# First feedback and comments on HL-LHC IT STRING Review recommendations

M. Bajko, M. Pojer  
HL-LHC IT STRING Coordination

*61<sup>st</sup> TCC HL-LHC 15<sup>th</sup> of November 2108*

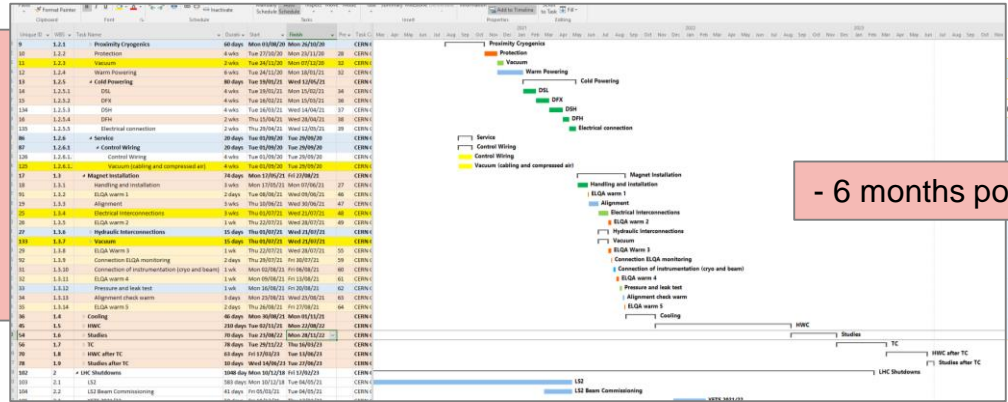
The master schedule of the IT-string presented to the review panel shows 10 months of installation starting September 2020, followed by 17 months of hardware commissioning and studies ending by end 2022. One year of operation has also been foreseen in 2023 as a margin for additional tests. The review panel stresses the need for disentangling operation and experimental programme and to contain the experimental programme to a bare minimum. The test programme shows as well a large number of resistive transitions provoked at high current.

**Recommendation 7:** Limit the IT-string test duration to end 2022 and concentrate the 2023-year resources on the LS3 preparation.

**Recommendation 8:** Confirm that the magnet design is compatible with the proposed quench programme.

To be confirmed by WP3

Experimental program = Studies

The number of resistive transitions will be re-estimates as in every quench provoked in a high current magnet all others will quench and as a consequence the number of provoked quenches can be reduced.

- 6 months possible
